**Region 6 Compliance Assurance and Enforcement Division
INSPECTION REPORT**

Inspection Date(s):	06/27/2019		
Media:	Water		
Regulatory Program(s)	NPDES		
Company Name:	MX-7 Dairy		
Facility Name:	MX-7 Dairy		
Facility Physical Location:	250 County Road 105 (31.9285, -98.66176)		
(city, state, zip code)	Comanche, TX 76442		
Mailing address:	250 County Road 105		
(city, state, zip code)	Comanche, Texas 76442		
County/Parish:	Comanche County		
Facility Contact:	Wayne Moerman	Owner – Not Present	
	manureisgood@yahoo.com		
FRS Number:	N/A		
Identification/Permit Number:	TXG920625		
Media Number:	N/A		
NAICS:	112120		
SIC:	0241		
Personnel participating in inspection:			
Juan Ibarra	EPA Region-6 ECD-WA	Inspector	214-665-8493
Noel Courts	MX-7 Dairy Consultant	Lowther Consulting	325-829-5264
EPA Lead Inspector Signature/Date	 {Inspector name}		8/20/19 Date
Supervisor Signature/Date	 {Supervisor name}		8/20/19 Date

Photo No. 3

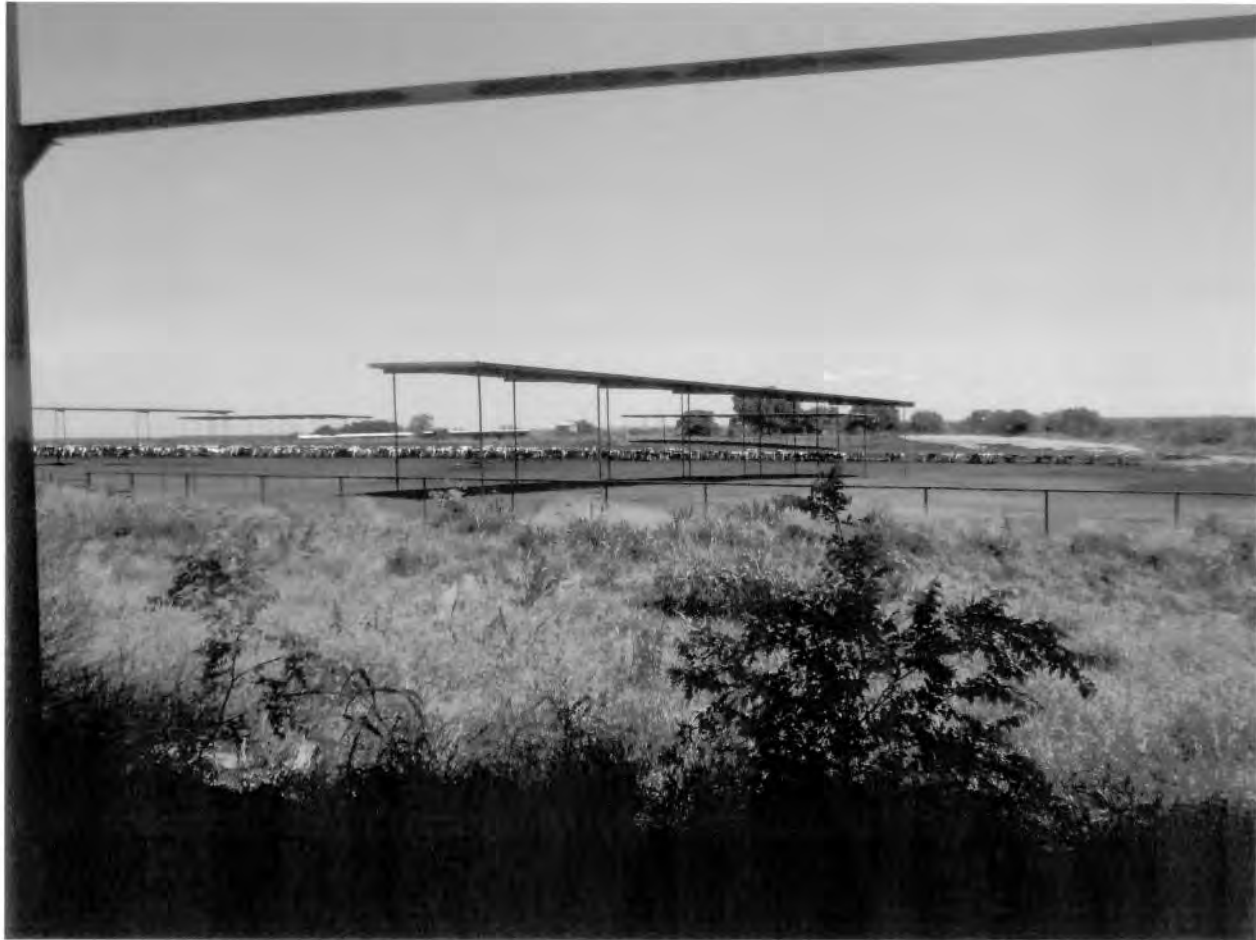
Description: Looking north at the dairy's cow pens located upslope of RCS 5.
